ILC-11-2 NRC Exam

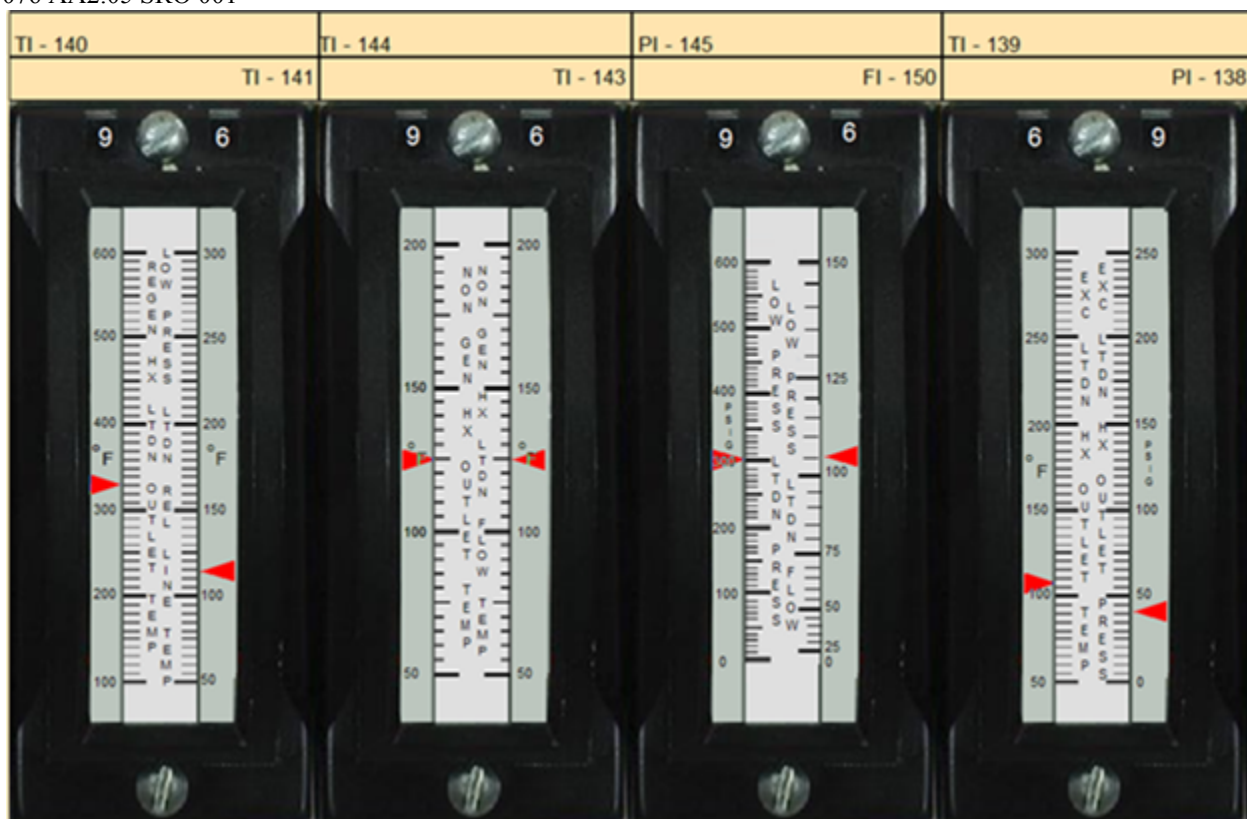
Do Robinson procedures actually allow a SG to be isolated prior to shutting down? If a SG is isolated at 100% power, how would the plant respond? My guess is that isolating the C SG at 100% power would result in a trip. Therefore, the first part of C and D are not plausible unless the licensee can provide sufficient justification for plausibility. **The isolation that is discussed in AOP-035 is local isolation of various paths that would not result in a complete isolation of the S/G.**

Have the licensee show the leakrate calc that results in greater than 77 gpm leakage.

Leak Rate = 154 gpm - 52.5 gpm = 101.5 gpm
